ADDENDUM NO. 1
Amelia River Waterfront Stabilization Parking Lots C & D
City of Fernandina Beach
Invitation to Bid # 21-06
Issued: May 25, 2021

III. Changes to Drawings: (See attached)

Drawing name: F:\PASSERO\FHB\99000047.0095 FHB Waterfront\Airport\C5-01-PROF_XSCT.dwg C6-1_XSCT May 25, 2021 5:57am by: EBredestege

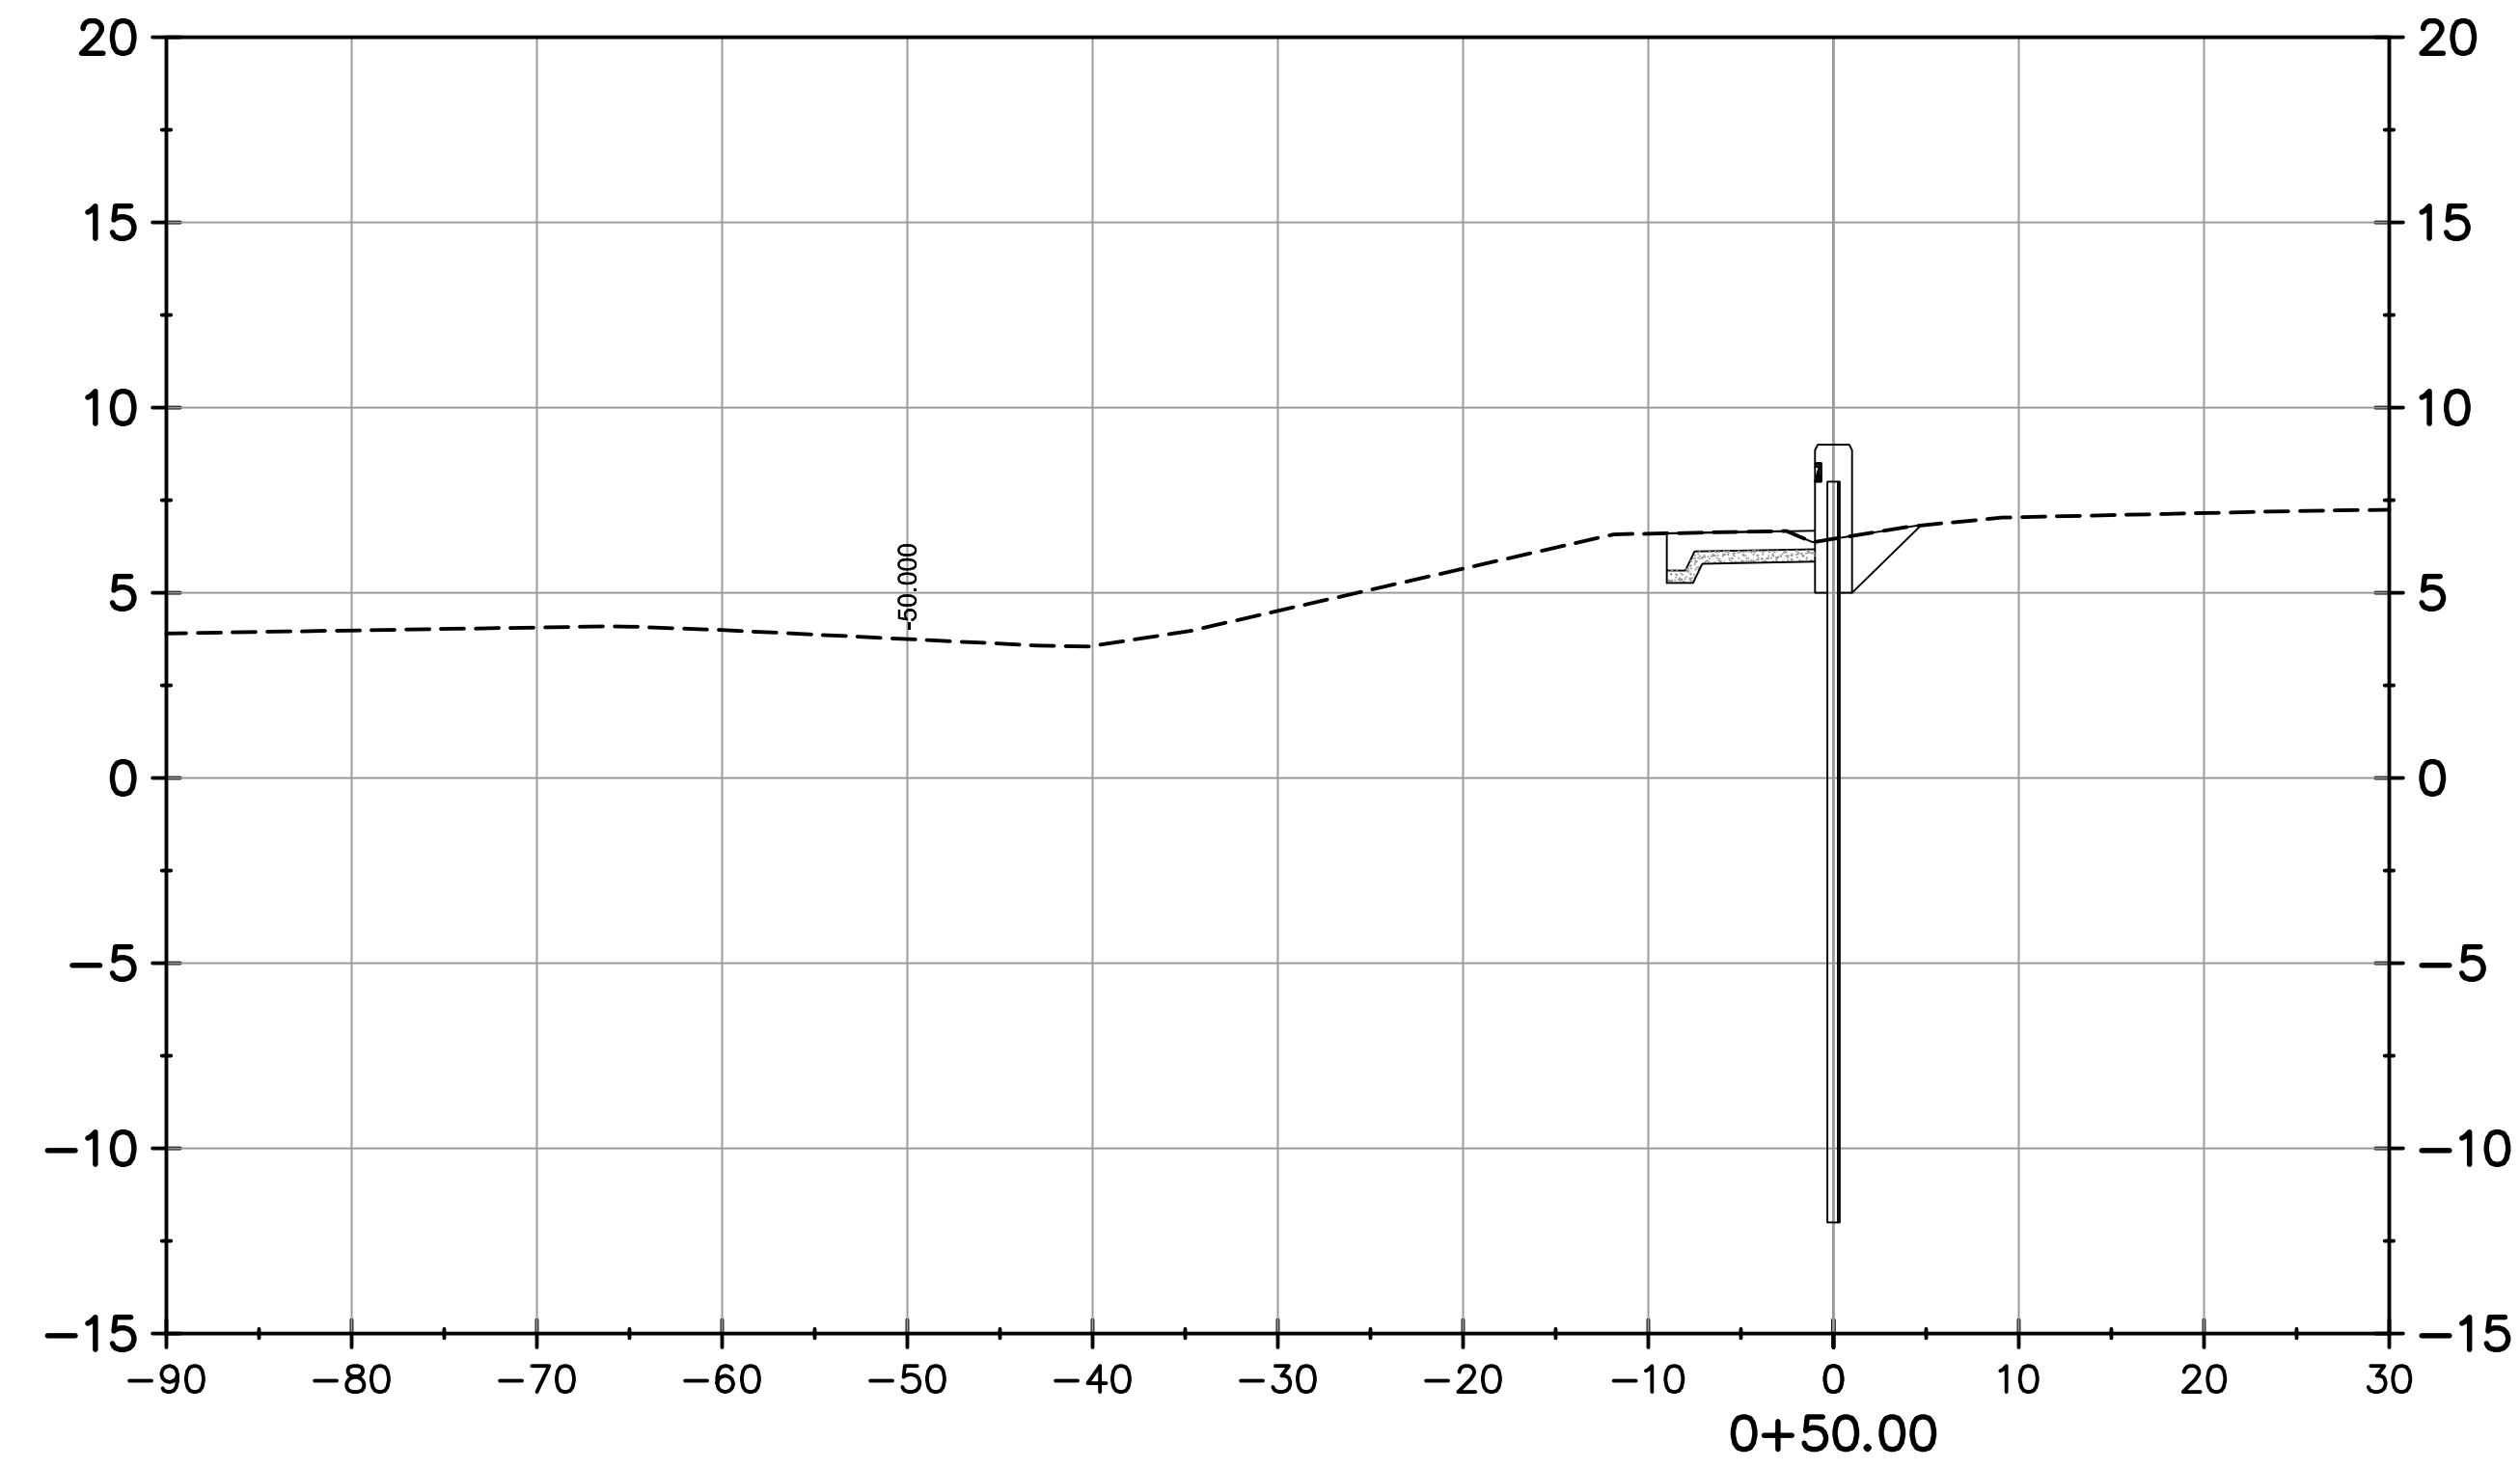
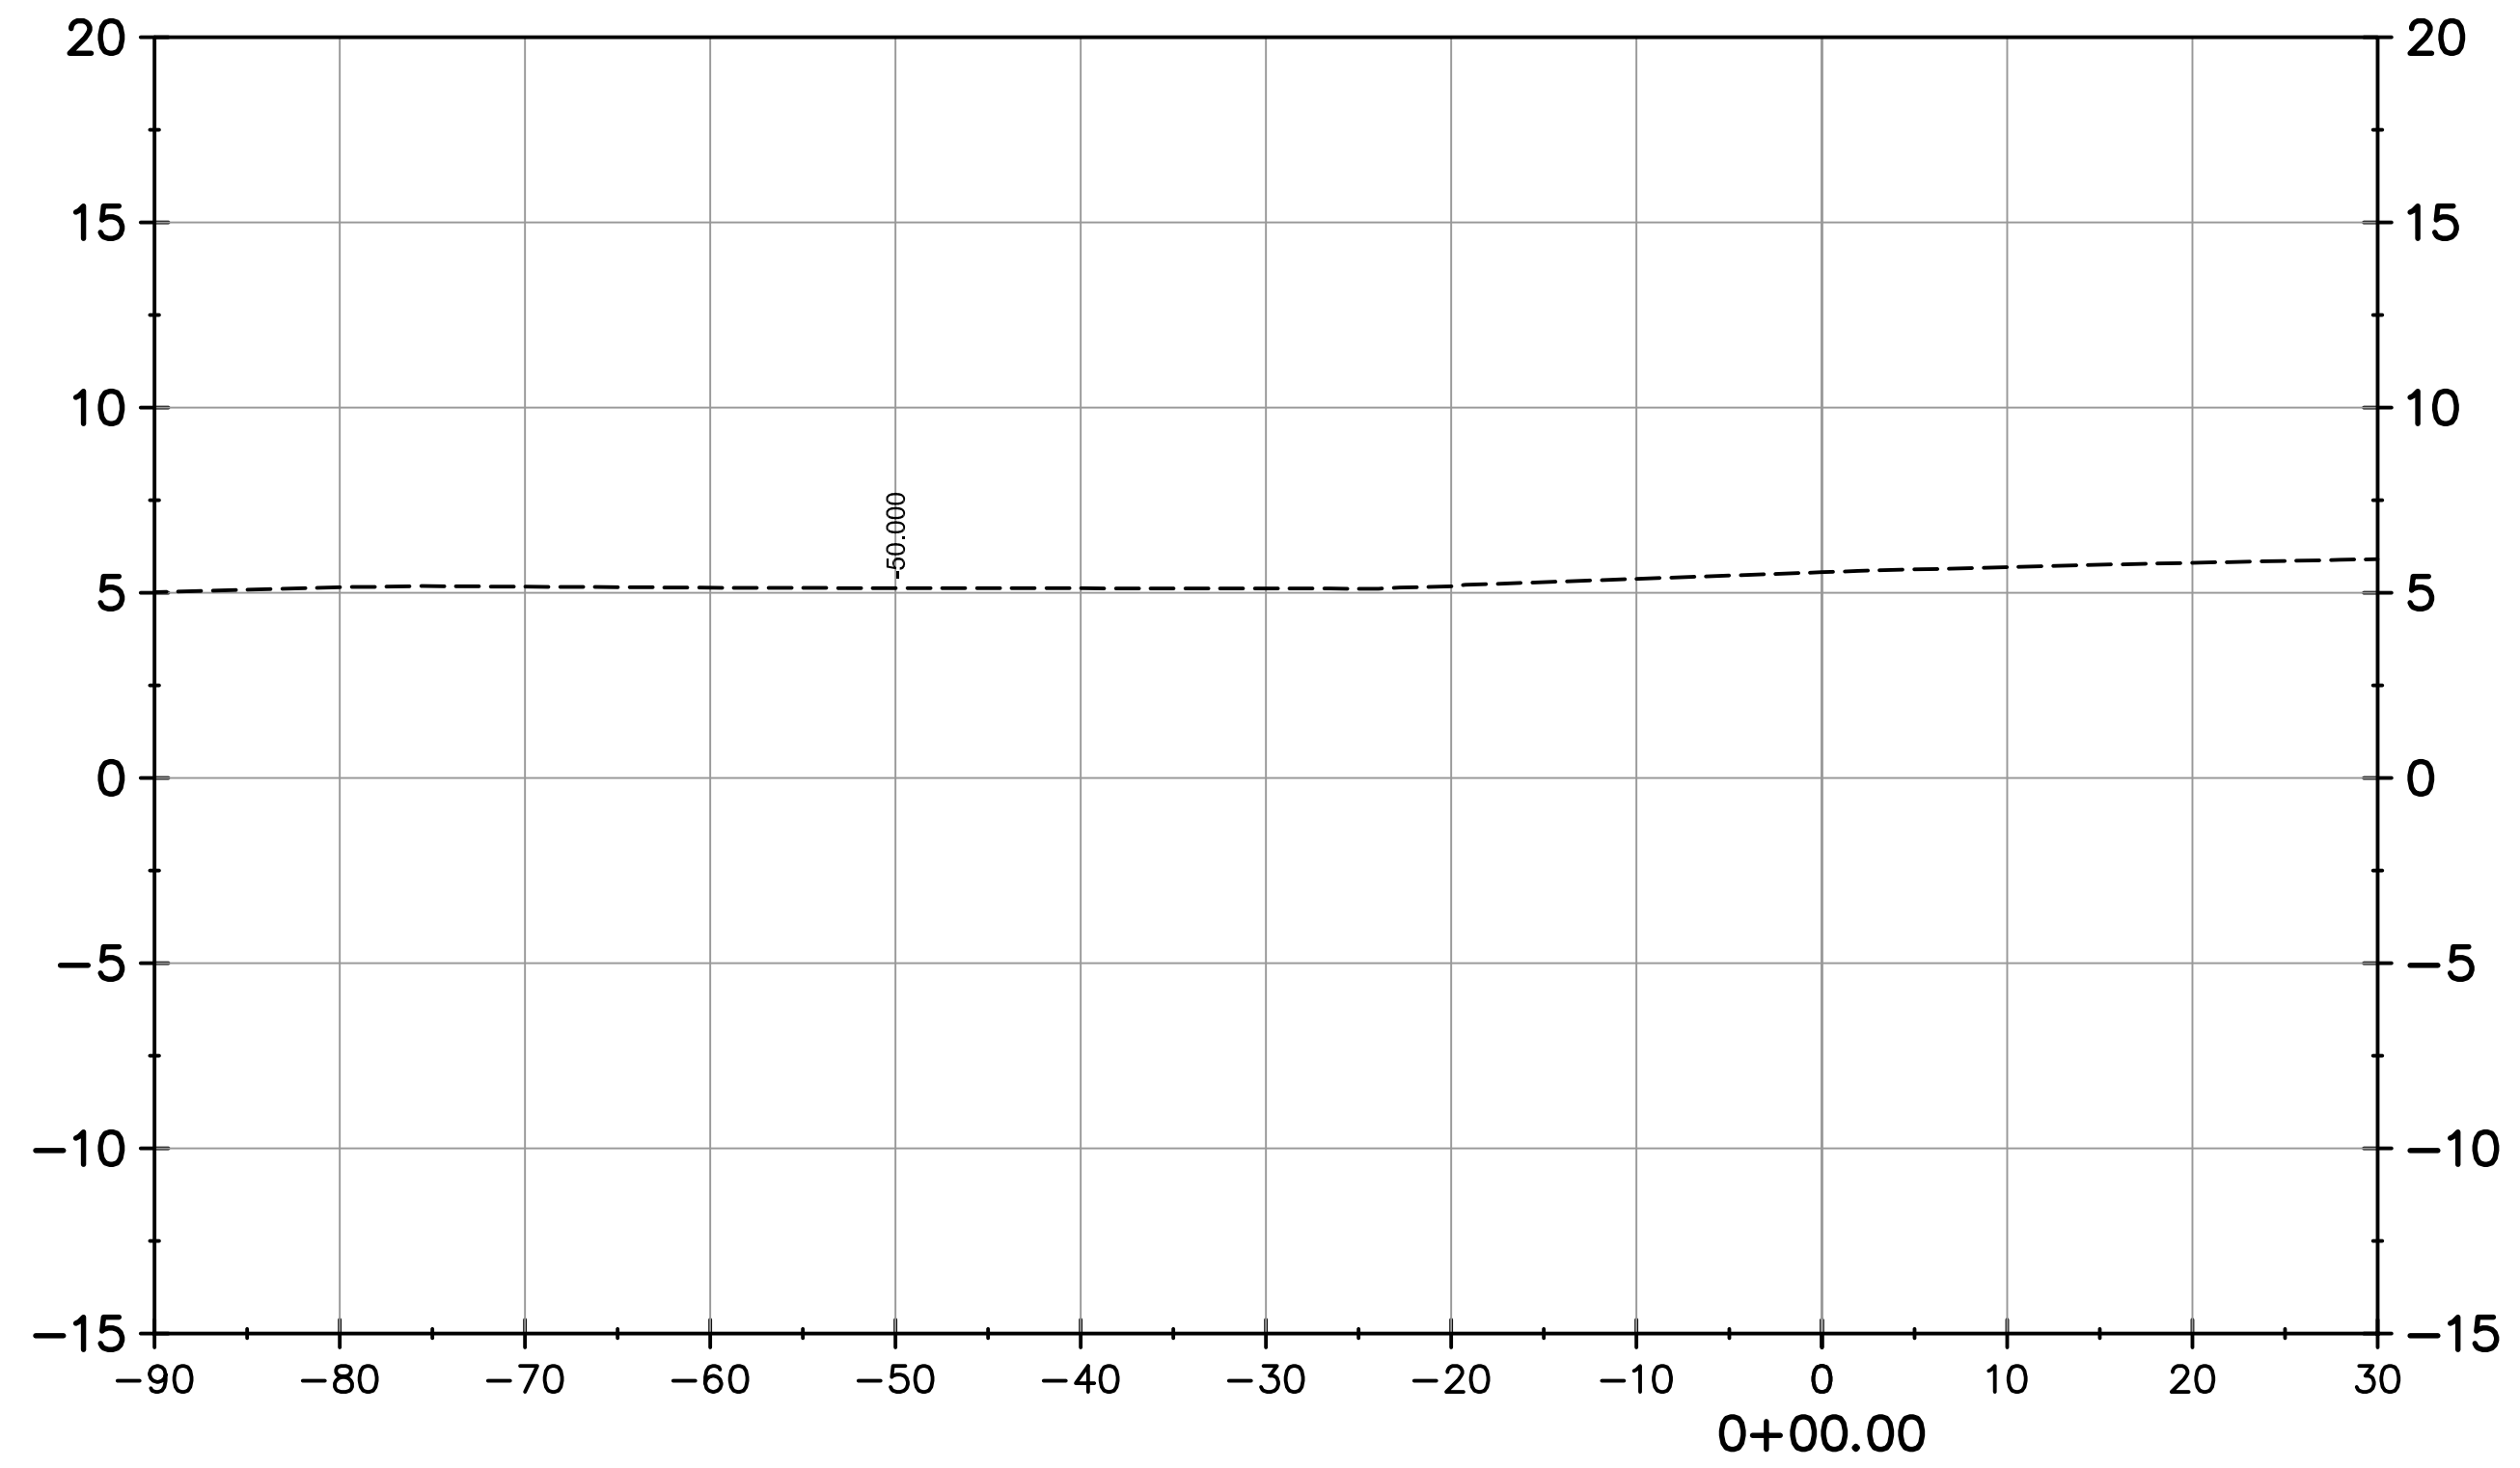
- 20) Sheet C6-1 - Revised I-Wall & Boardwalk Alignment and Cross Sections Adjusted.
- 21) Sheet C6-2 - Revised I-Wall & Boardwalk Alignment and Cross Sections Adjusted.

ALIGNMENT MOVED; CROSS SECTIONS ADJUSTED
